PUD-84
 Frank and Barbara Berlogar

Re: Proposed Berlogar Development

Application for Planned Unit Development Plan (PUD) approval to subdivide an approximately 37.25-acre site located at 88 Silver Oaks Court into three single-family residential lots: two new lots and one lot for the existing dwelling and accessory structures. Zoning for the property is PUD-HR/OS (Planned Unit Development – Hillside Residential/Open Space) District.

PRELIMINARY SITE PLAN 1
BERLOGAR PROPERTY

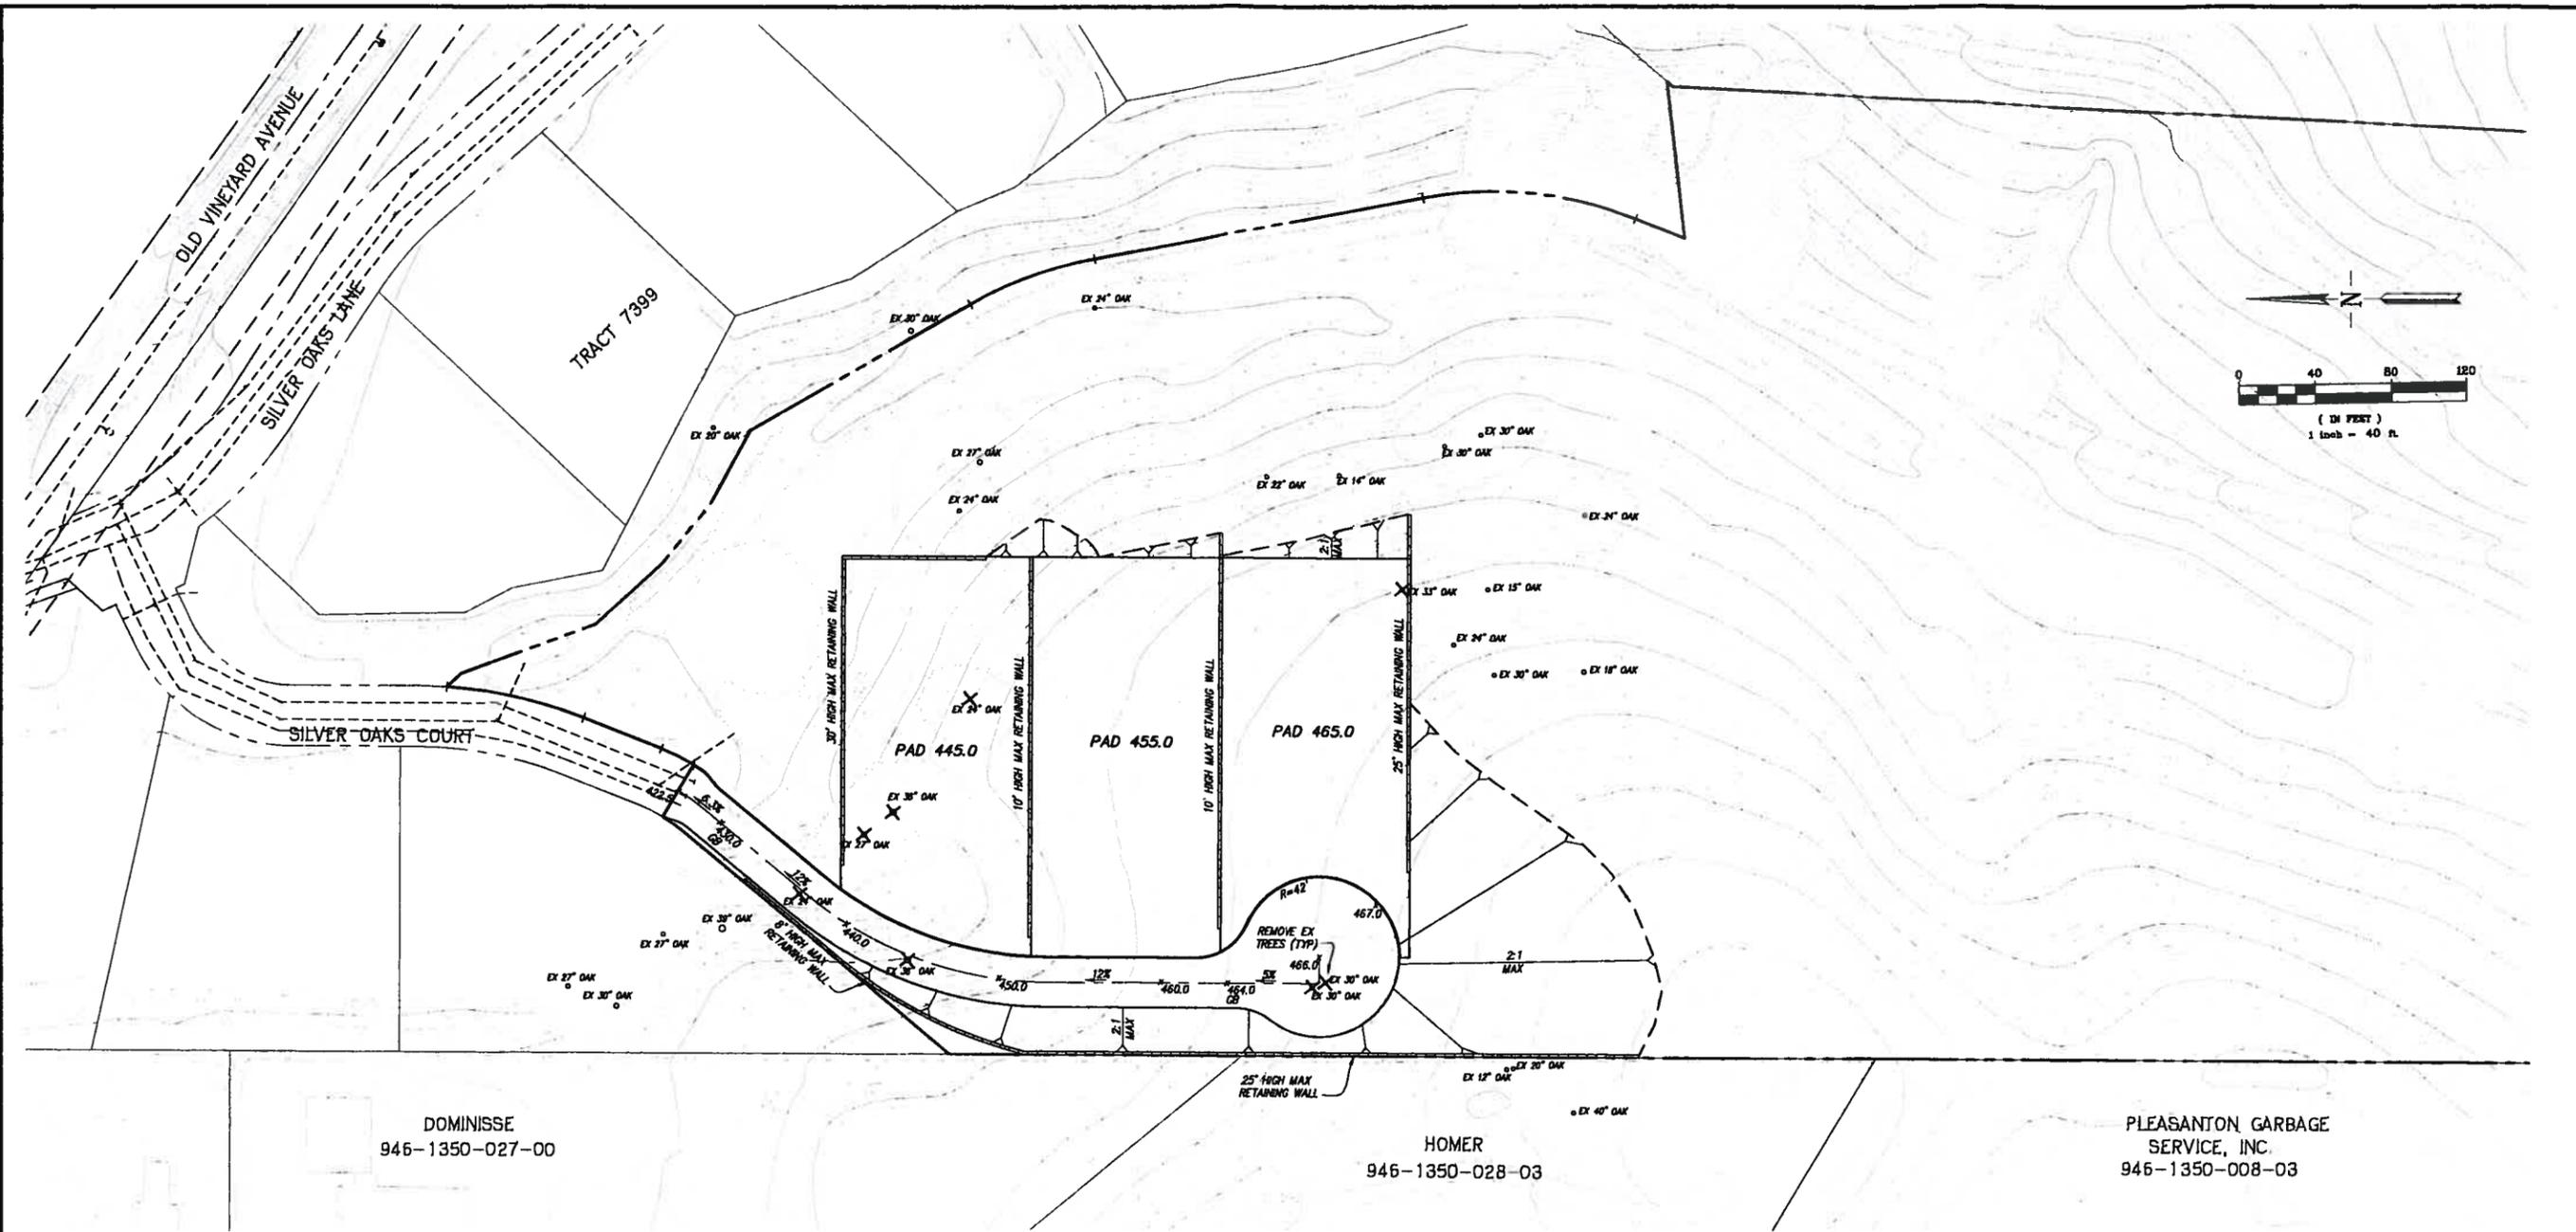
The Development is at significant elevation to the existing HOA homes and properties. The proposed retaining walls positioned below and above the new access road will in some areas exceed 11 foot vertical, with the sheer wall facing the back yards of existing HOA homes. The access road to the Development winds up the center of the hill facing the existing HOA homes and property. Traffic noise and headlights, and residential lighting will intrude on existing homes.

Therefore, the Development lots, access road and retaining walls should be screened with evergreen tree planting and supported by permanent irrigation. The screening may include landscaping installed on the HOA open space between the existing homes and the Development, in consultation with the HOA. However, even if a large number of evergreen trees were planted, it would still take many years to substantially screen the Development and provide an adequate buffer for the HOA homes.

1. As the both proposed properties and the access drive will have elevation (from level with, to >75 feet higher than my property) and a direct line of sight into my backyard and back windows, what kind of screen and visual mitigation is going to be done? What are the additional open space requirements? My back view will transition from an open hill side to a residential area.

2. Why is the property footprint outside the area indicated in the vineyard corridor master plan? Why is the property allowed to go to the highest point on the hill?

3. Is the access road a private or public road? Are there any sound barriers to the drive?
4. Related to the driveway, why can't this road go straight up the back side of the properties (as shown in the vineyard corridor plan) instead of cutting through the hillside in front of the homes? As an alternative, why can't the existing private drive way act as the access road (instead of having to create another drive way), and then have the drive access the proposed properties from the east side of the hill ?

FIGURE IV - 2

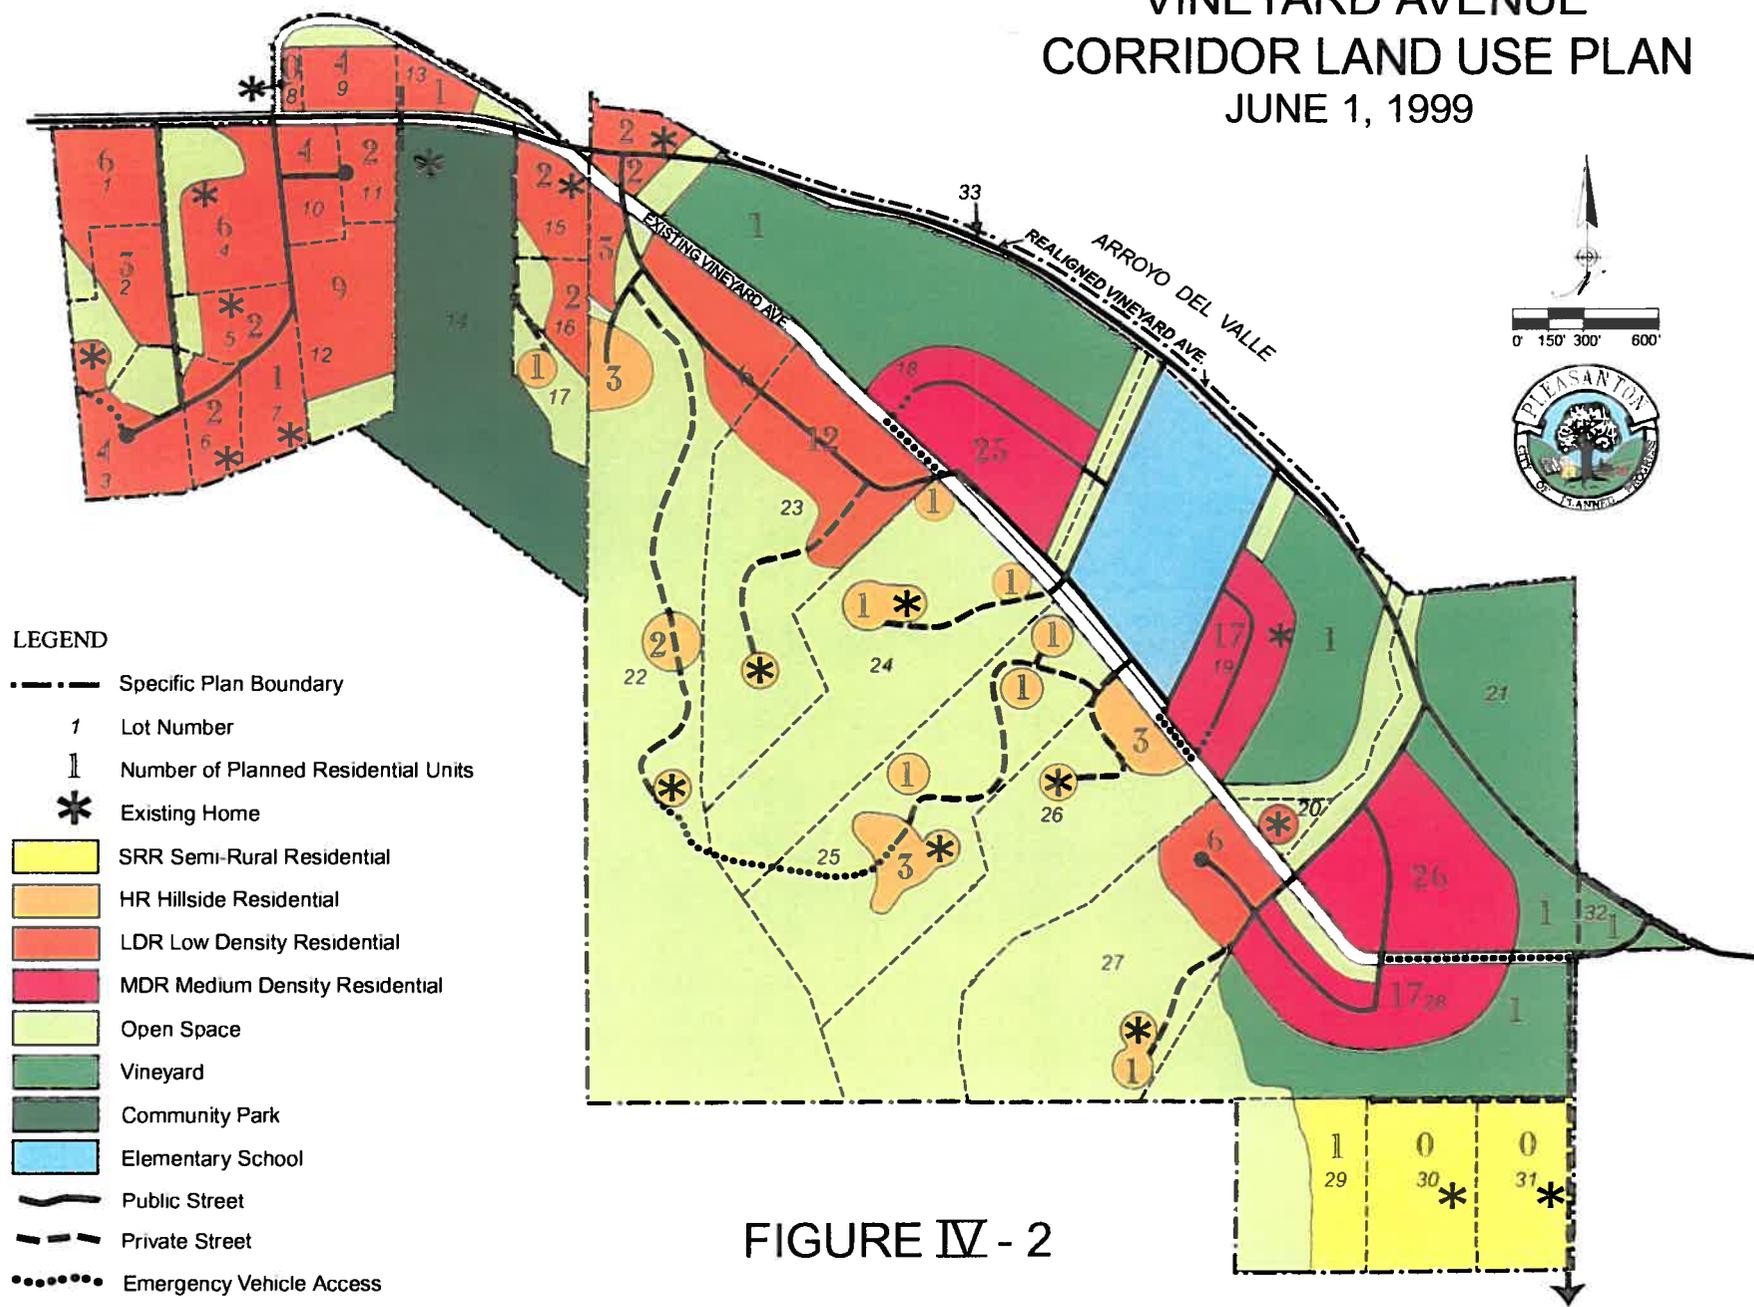
There was quite a bit of discussion at the Planning Commission meeting regarding the significance of the "dots" shown on Figure IV-2 of the Vineyard Avenue Specific Plan (page 20). The Planning Commission asked staff to provide an interpretation of the significance of the location of these dots.

The dots show the number of planned residential units with an asterisk for an existing home. Where more than one unit is planned, the dots take on an irregular shape presumably signifying the general location for the units. These "dots" or "blobs," as the case may be, do not appear to be randomly placed. However, Figure IV-2 does not have the precision of topographic contours or other descriptive features that would specify an exact location. Again, as noted on page 23 of the Specific Plan, there was some flexibility built into the Specific Plan to allow specific site development standards to be looked at through the City's PUD process and varied "for unusual site conditions as long as any new standards are consistent with the intent of the Specific Plan."

- c) Residential Development Standards (p. 25) – *"In HR areas, all home sites must be located within the designated development areas as generally depicted on the land use plan (see Figure IV-2). Lot lines may extend into land designated as Open Space, but primary residential buildings and residential accessory structures may only be sited within the designated development areas.* (bold added for emphasis)

The location of the designated development area per the Specific Plan for Lot 22 is not imprecise, it is not a general 'blob' as previously mentioned by Staff. To the contrary, its location, size and shape fit the terrain and is intended to minimize disruption to existing topography. Moving the site to the top of the hill clearly violates the intent and letter of the Specific Plan and adversely affects the existing properties and future developments for which the Specific Plan should preserve the Open Space view and residential buffer.

The relocation or expansion as proposed by the Development contemplates a deviation of 100-300 feet in horizontal distance and over 50 feet elevation to the top of the hill, and a 25 foot partial flattening of the hill. To allow for this material deviation of the designated development area would amount to a de facto amendment to the Specific Plan. The Planning Commission Staff have stated that they have some discretion to approve deviations from the designated development areas, and that the words "generally depicted on the land use plan" afford them this flexibility. However, Staff's interpretation ignores the next sentence in the Specific Plan, which expressly limits this flexibility, by clearly stating all "*primary residential buildings and residential accessory structures may only be sited within the designated development areas.*" To overlook this second sentence renders moot the delineated requirements the Specific Plan that intentionally restrict building structures to only within the designated development areas.
